VIRGINIA ELECTRIC AND POWER COMPANY
RICHMOND, VIRGINIA 23261

VIRGINIA ELECTRIC AND POWER COMPANY
NORTH ANNA POWER STATION UNITS 1 AND 2
PROPOSED LICENSE AMENDMENT REQUEST
OPEN PHASE PROTECTION PER NRC BULLETIN 2012-01
RESPONSE TO REQUEST FOR ADDITIONAL INFORMATION

Response to NRC Request for Additional Information
Regarding the
Proposed License Amendment Request
Open Phase Protection per NRC Bulletin 2012-01

RESPONSE TO NRC REQUEST FOR ADDITIONAL INFORMATION
NORTH ANNA POWER STATION UNITS 1 AND 2

Drawings Illustrating the Connection of PT Fuses, BE1-47N Relays, and the ABB-60 Relay for the Unit 1 H Bus

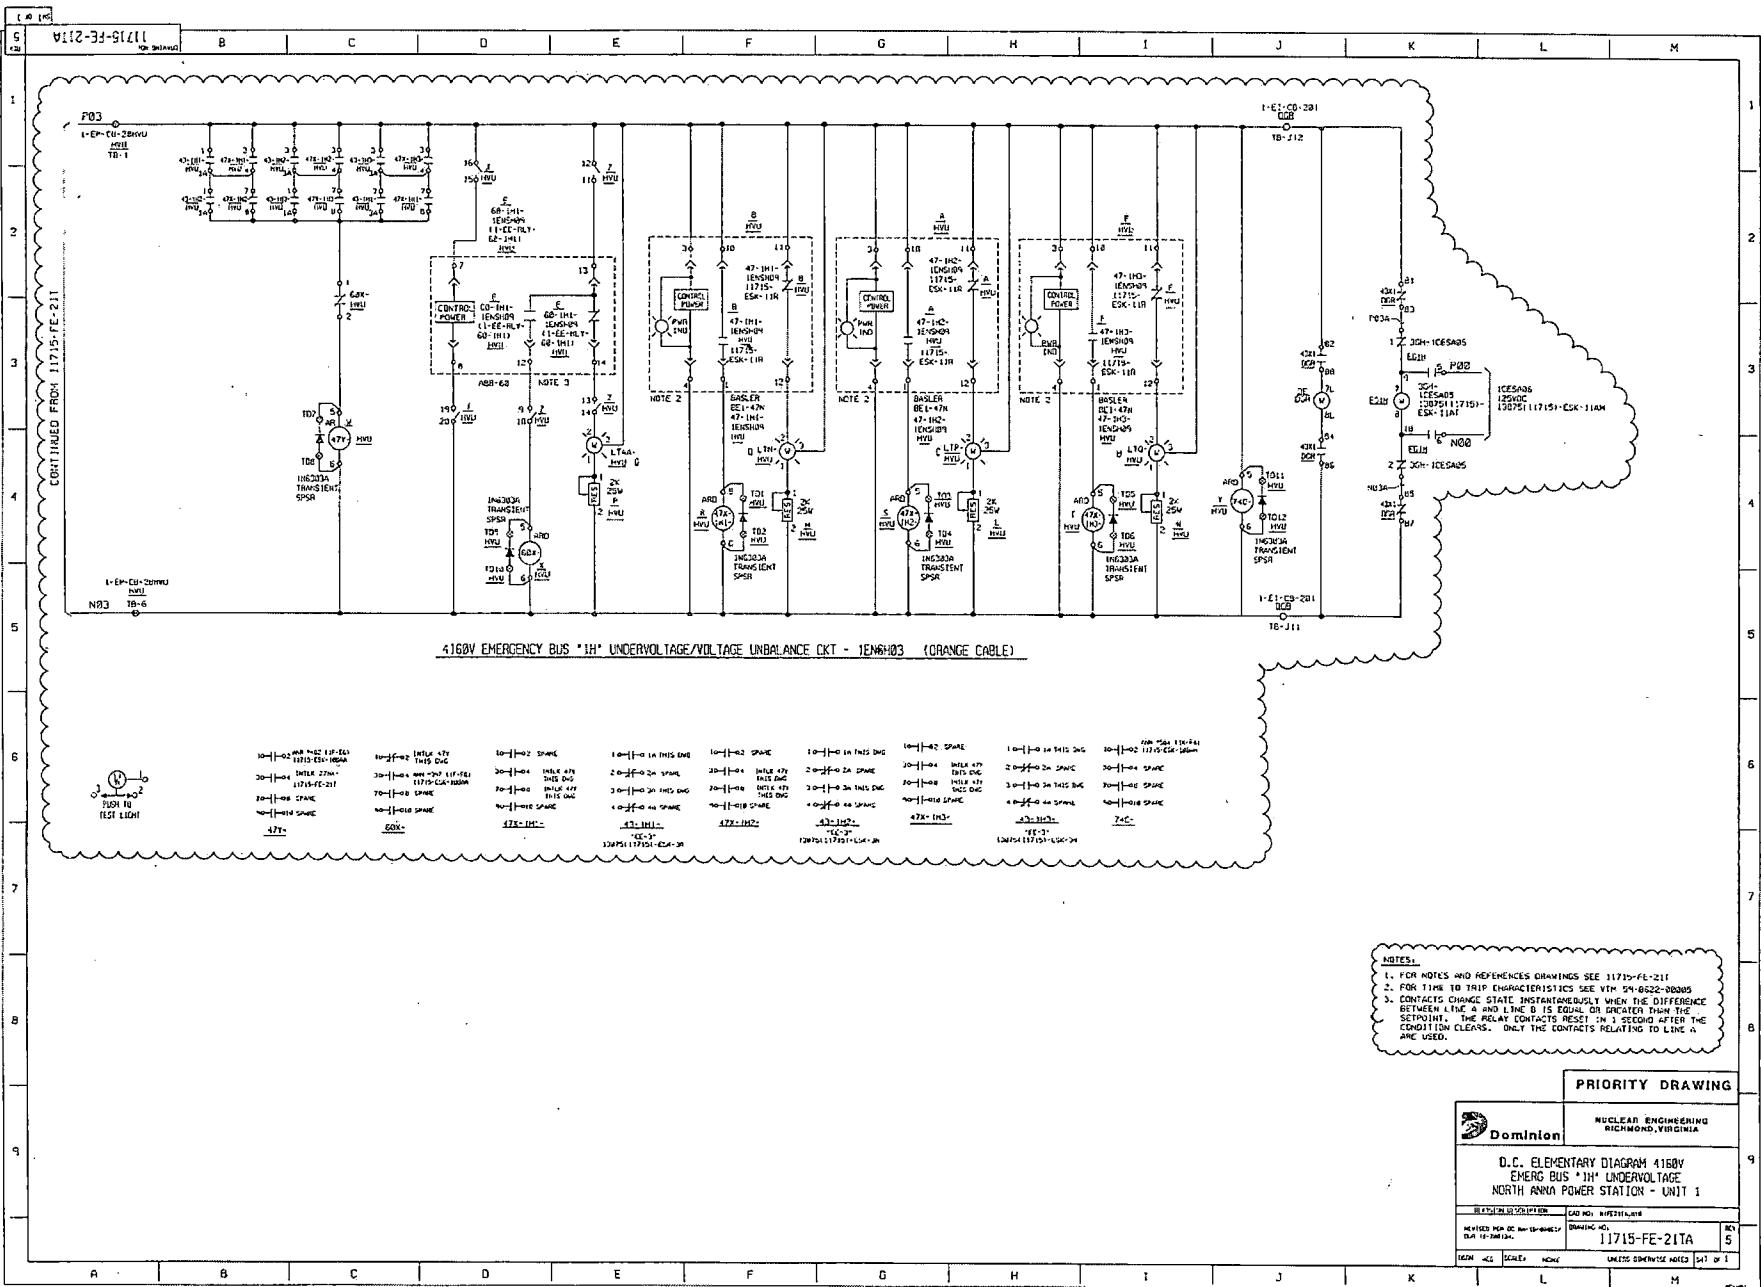
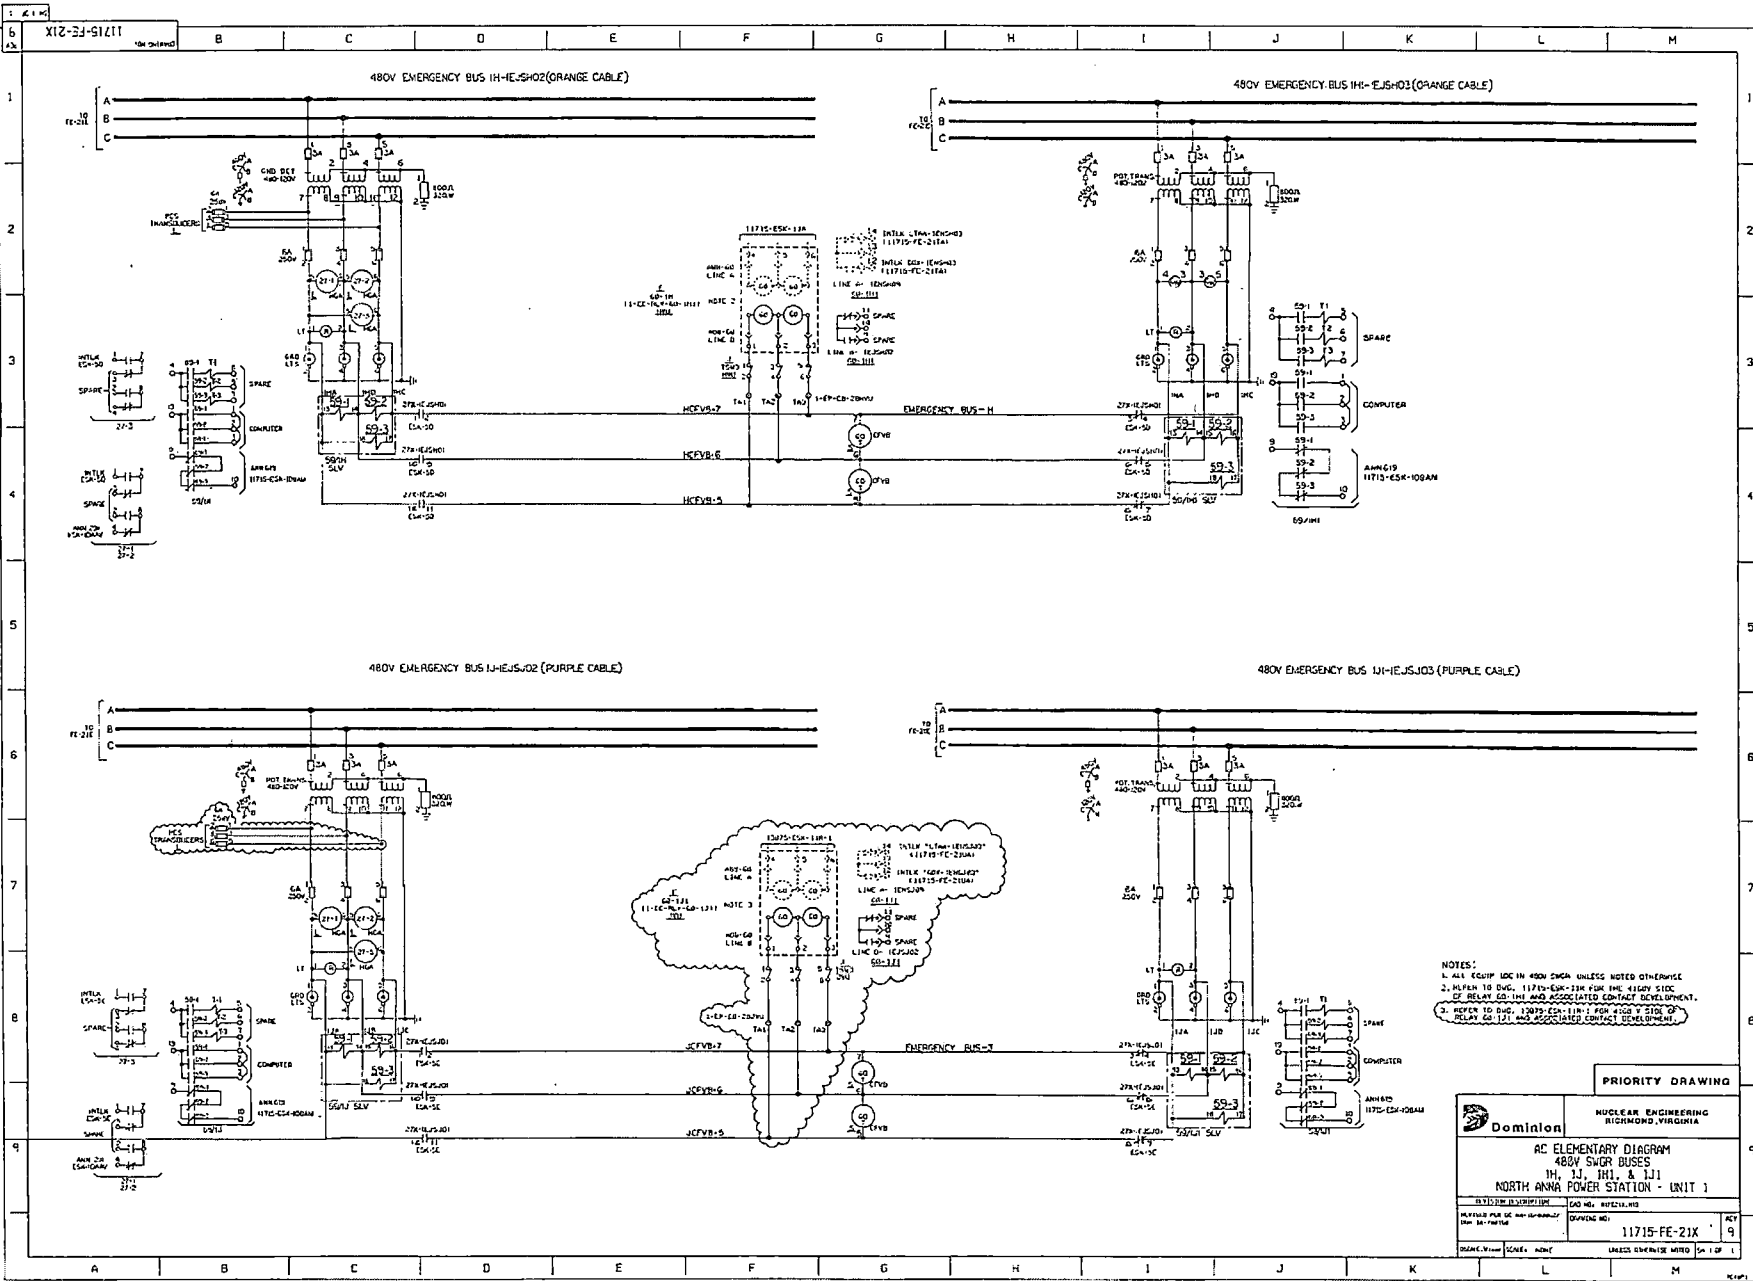
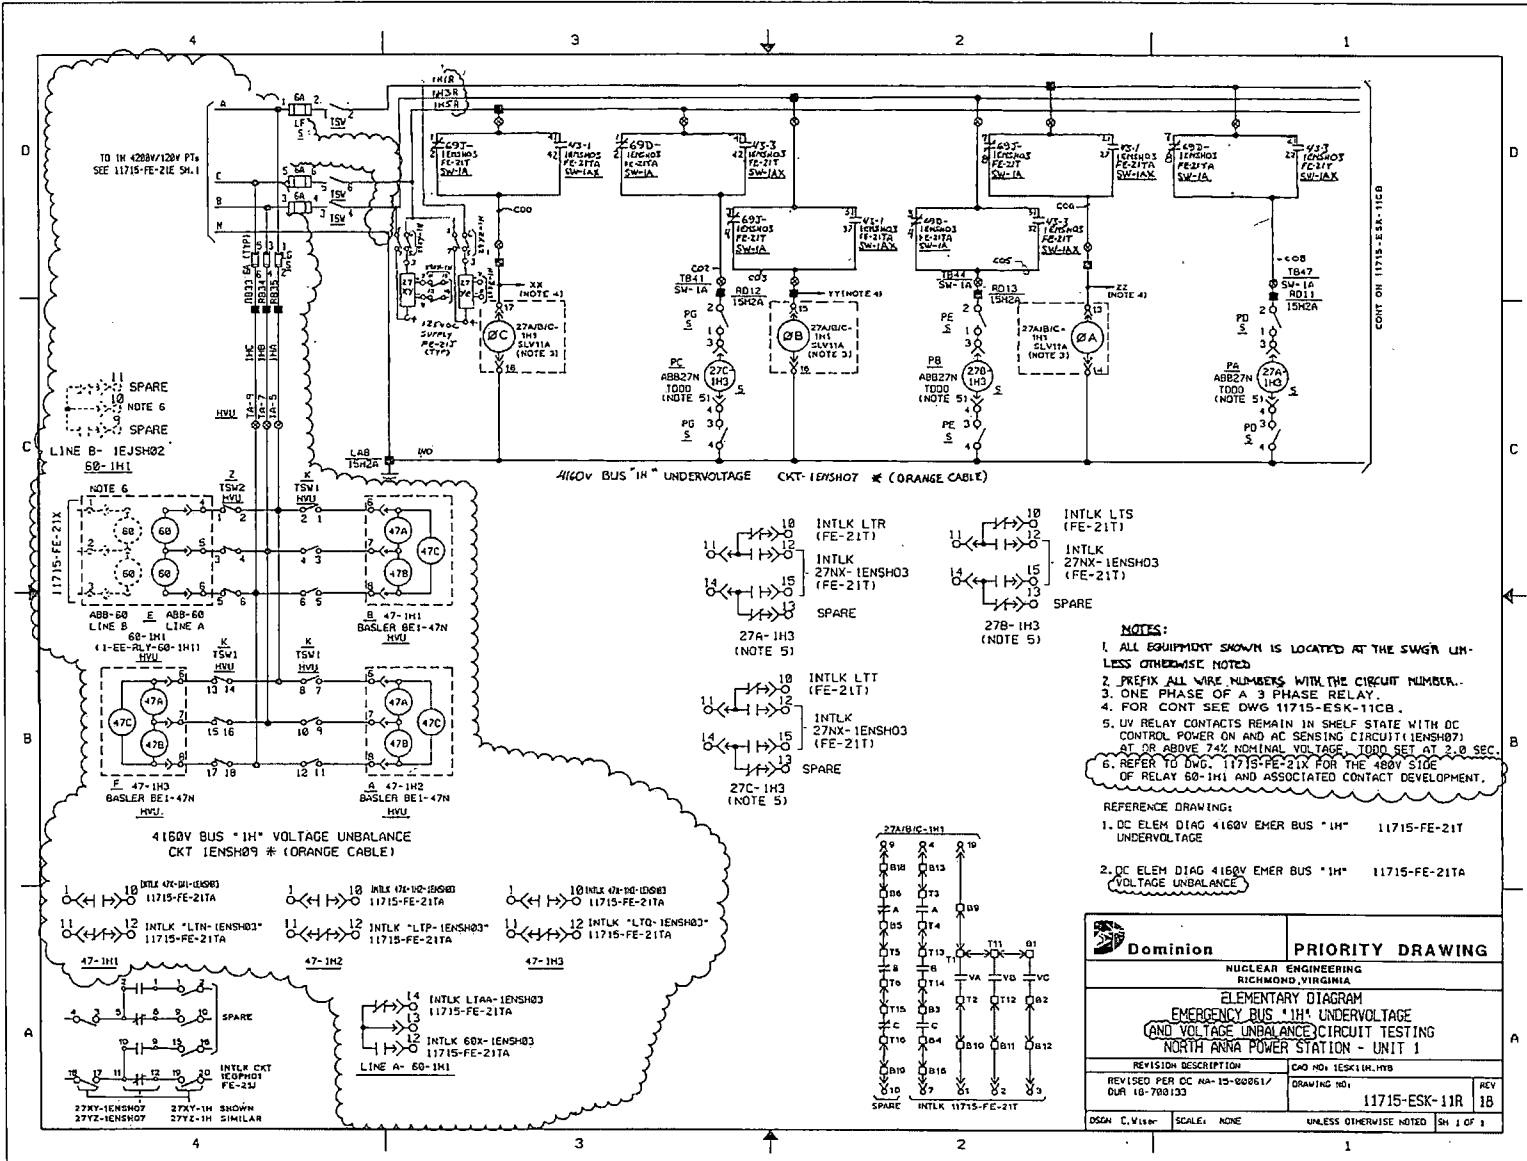
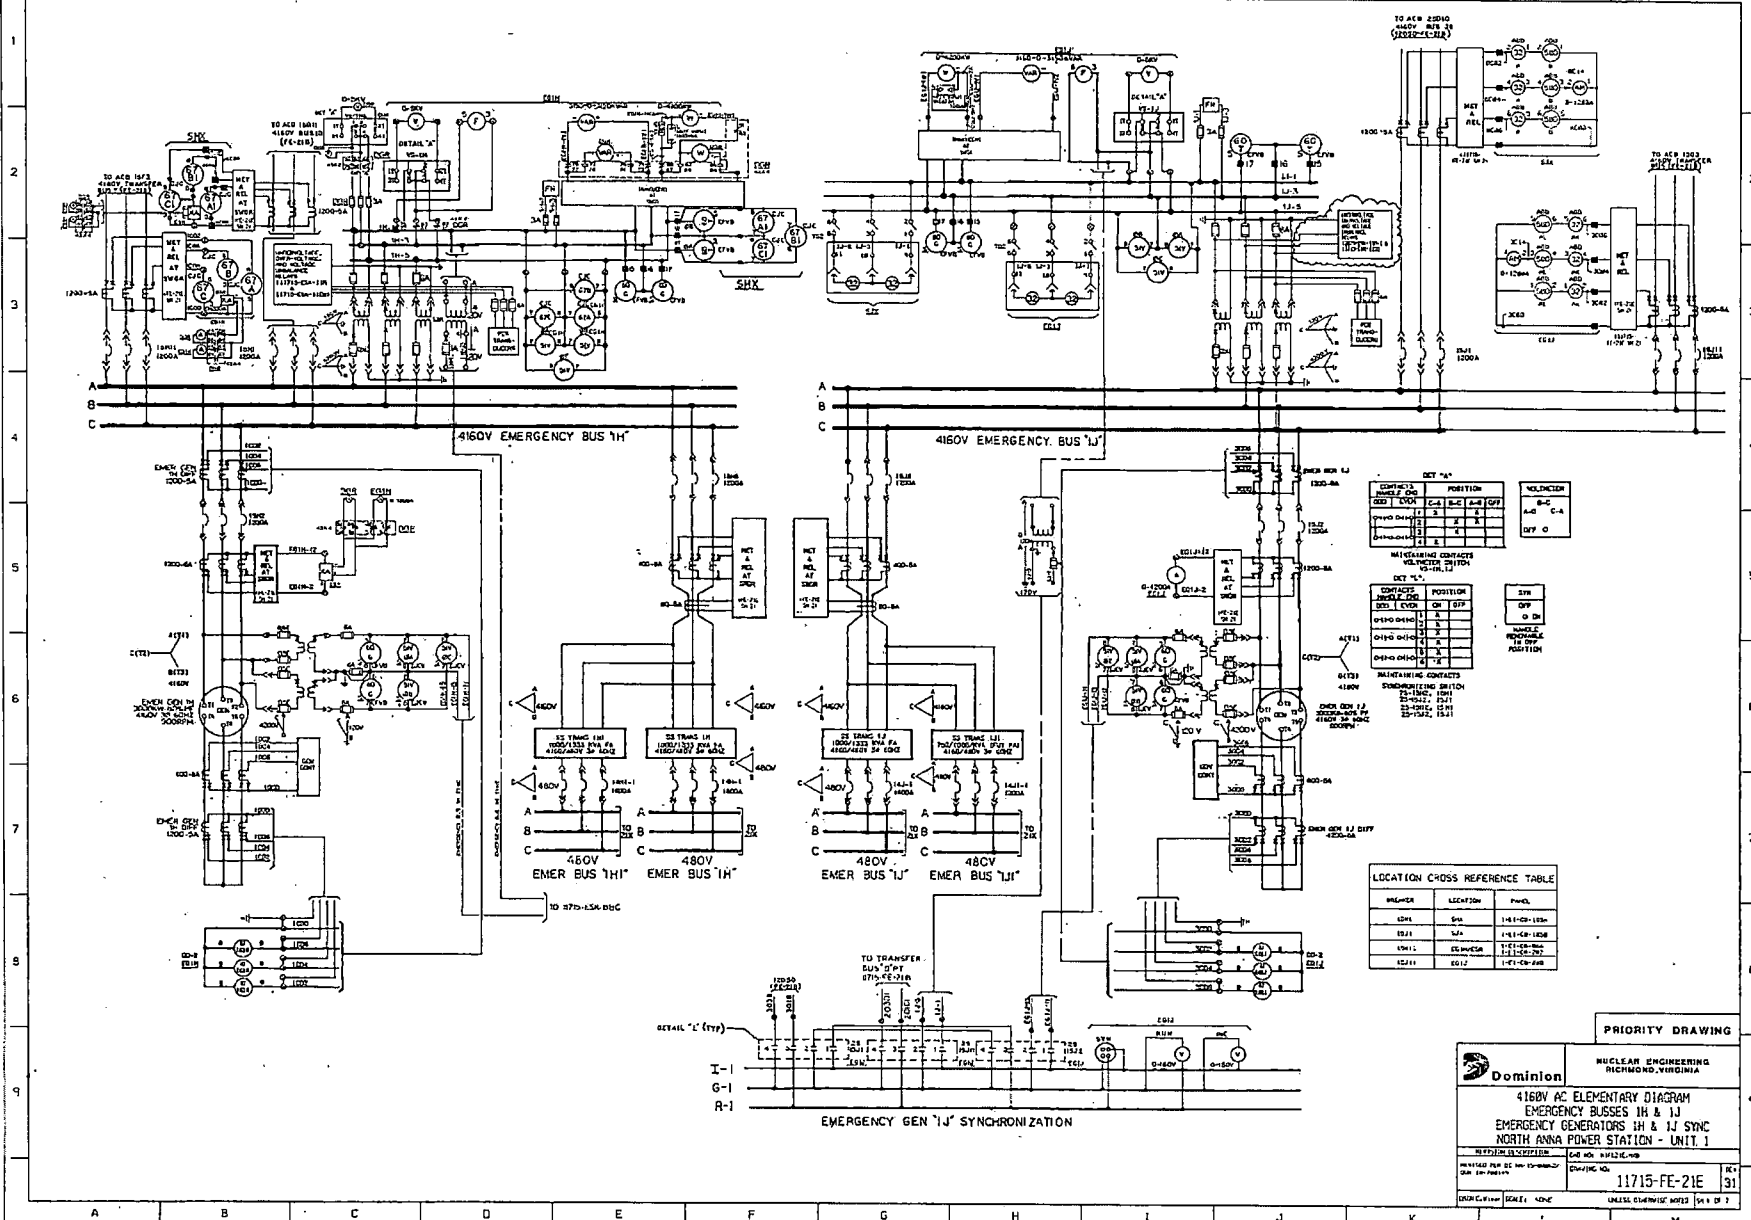
Please provide the connection/schematic diagrams(s) illustrating the connection of PT fuses, BE1-47N and ABB-60 relays, as described above, for one of the 4160 V safety-related busses.

The portions of the station drawings which illustrate the connection of PT fuses, BE1-47N relays, and ABB-60 relay for Unit 1 H bus are provided in Attachment 5.
